Section 16 Planning Application for Proposed Commercial Use at Phase IIa Development of an Approved Master Layout Plan (MLP) with Minor Relaxation of Plot Ratio Restriction (Proposed Amendments to the Approved MLP for Comprehensive Residential, Commercial, Social Welfare Facility and Public Vehicle Park Development; with Minor Relaxation of Plot Ratio Restriction Approved at Phase III) at Lot Nos. 461 RP, 462 S.B, 463 S.B, 464 RP, 495 RP and 539 S.B in D.D. 116, Yuen Long Town Lot (Y.L.T.L.) 504, Y.L.T.L. 544 (Part) and Adjoining Government Land, Yuen Long, New Territories (Application No. A/YL/333)

Reference is made to the Further Information for captioned application submitted to the Town Planning Board (the Board) on 7 August 2026 and subsequent departmental comments received via the Tuen Mun and Yuen Long West District Planning Office (DPO/TMYLW) in September 2026.

In response to the comments from various government departments, we herewith submit 4 copies of responses-to-comments (RtoC) table with the following attachments:

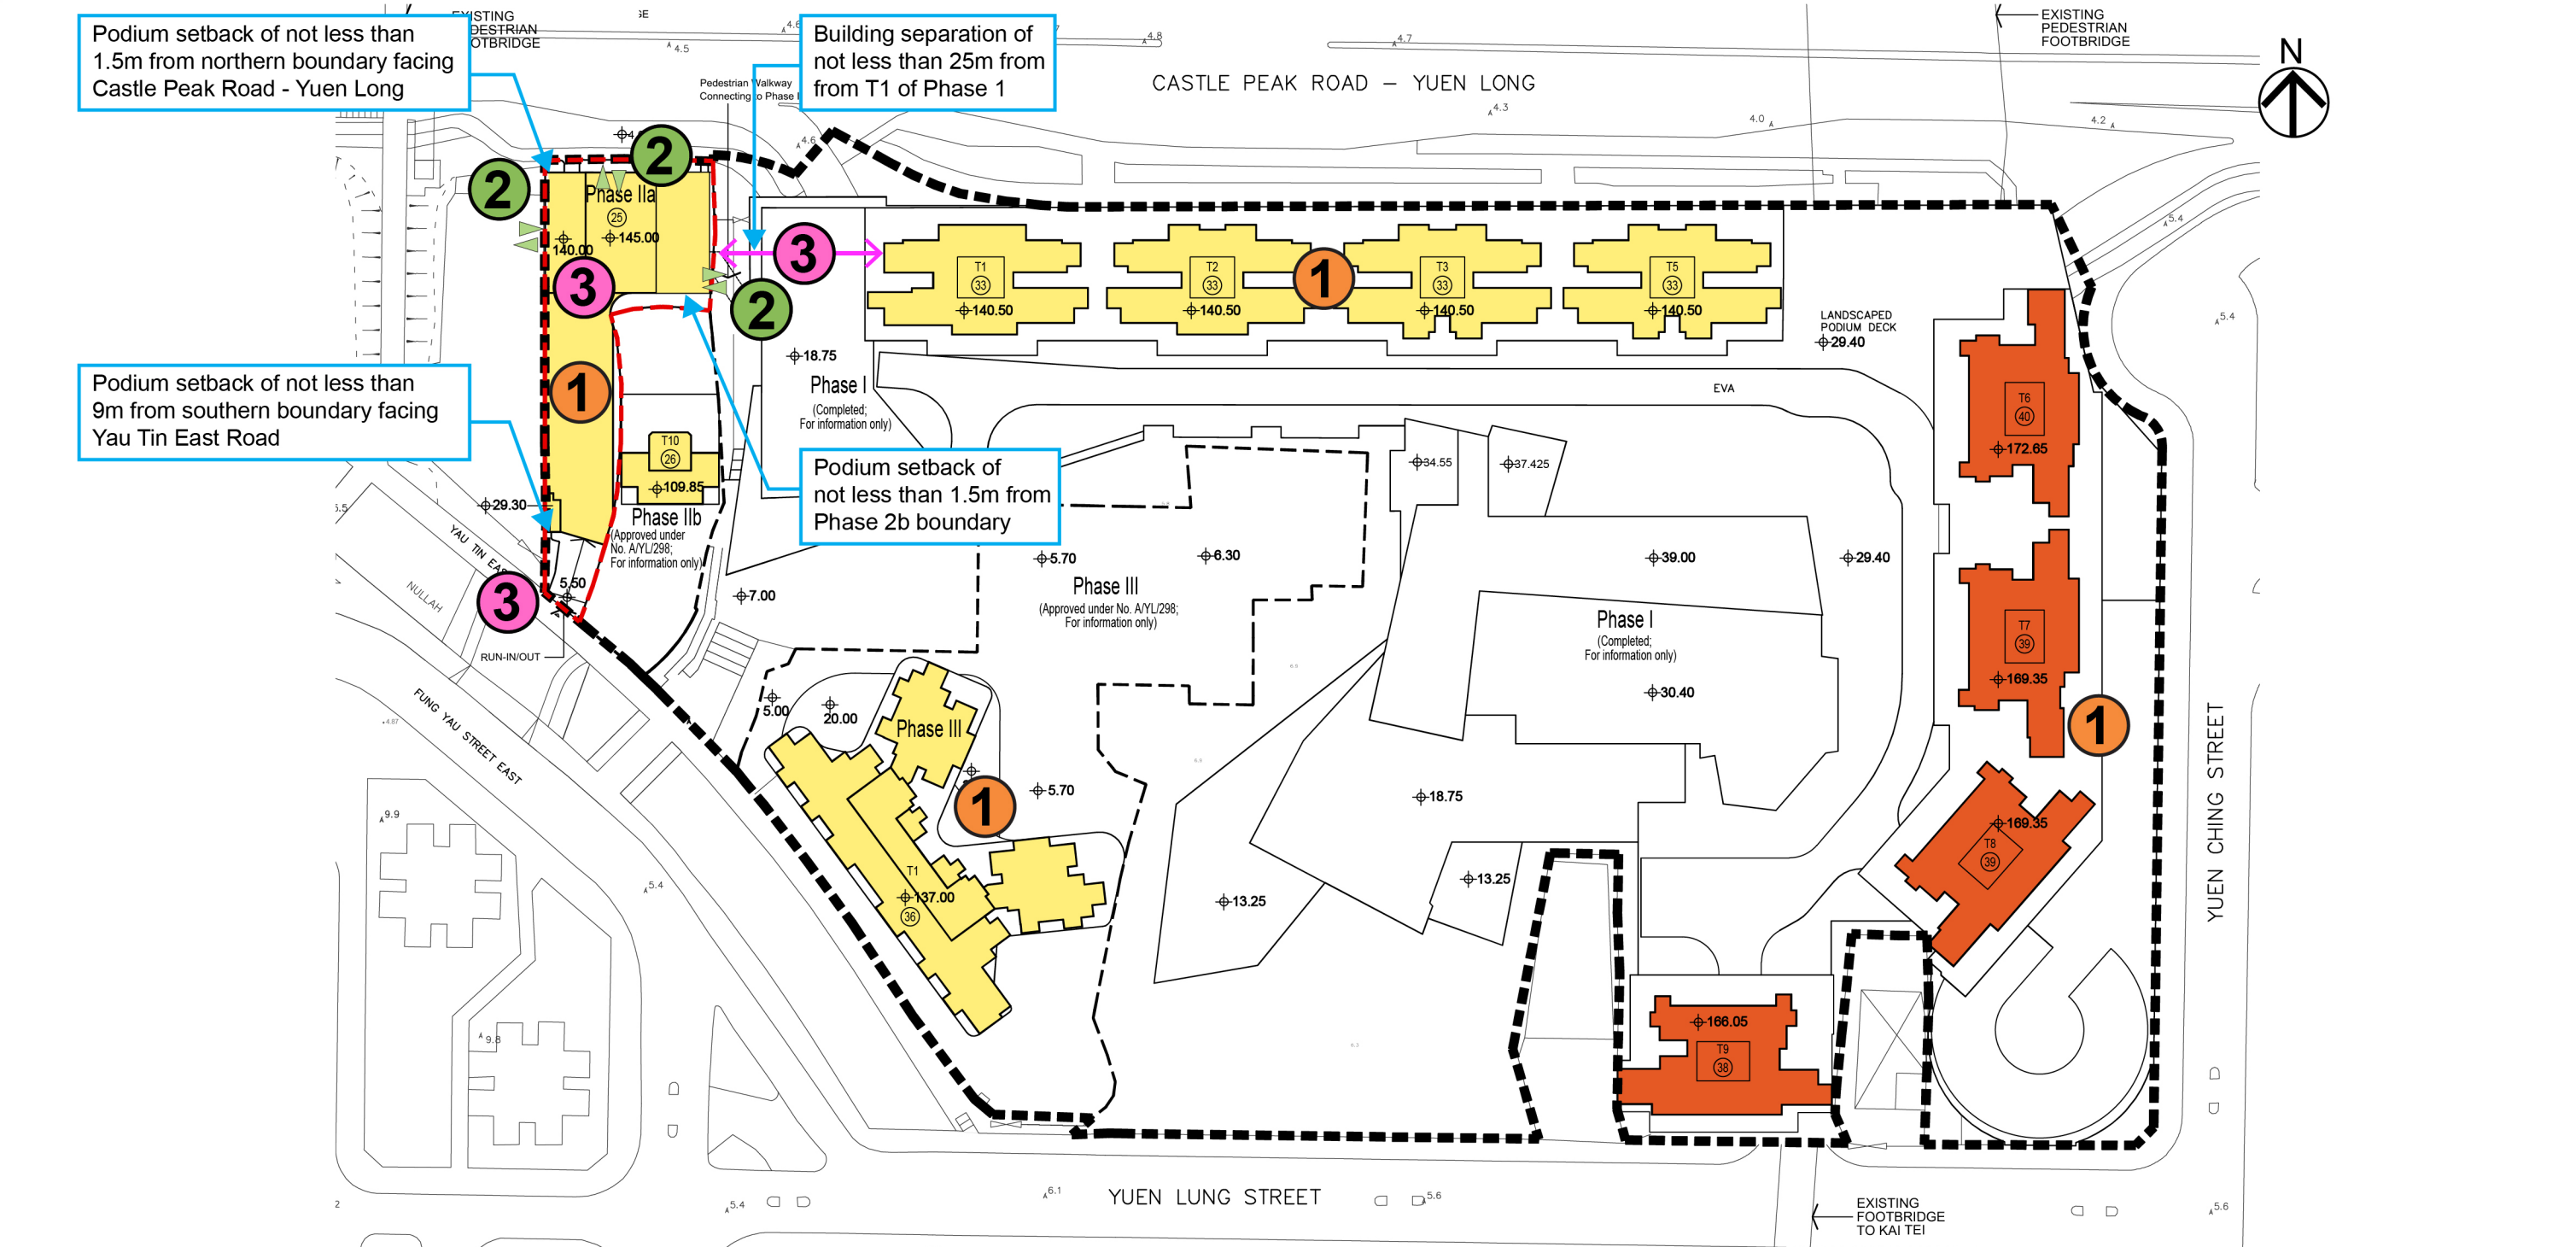
2.2.	Please advise the <u>width</u> of setback in metres to be provided along Yau Tin East Road and full-height building setback from Castle Peak Road-Yuen Long respectively. Please indicate the width of setbacks on Figure 4.13 of the Planning Statement. Please also elaborate the applicant’s proposal on “while the frontage accommodates the vehicular entrance, a setback of the semi-open-air carpark fronting the existing nullah along Yau Tin East Road is reserved...” at para. 4.2.5 of the planning statement. Please advise if the statement could be interpret as setback from podium level.	The width of building setback along Yau Tin East Road and Castle Peak Road-Yuen Long are not less than 9m and 1.5m respectively. Figure 4.13 of the Planning Statement has also been updated accordingly in Attachment 1 . Please also be confirmed that the relevant texts quoted in para. 4.2.5 refers to the setback from podium level only.

Departmental Comments	Responses to Comments
2.3	Please advise the <u>width</u> of building separation in metres to be provided from Phase I (Tower 1) and Phase IIb building block respectively. Please indicate the width of separation and setback on Figure 4.13 of the Planning Statement accordingly.	The width of building separation from Phase I (Tower 1) is not less than 25m. The width of building setback from Phase IIb boundary is not less than 1.5m. Since the building block and disposition in Phase IIb are indicative only and subject to refinements by the future developer, the building setback of Phase IIa from Phase IIb's boundary is provided instead. Figure 4.13 of the Planning Statement has also been updated accordingly in Attachment 1 .
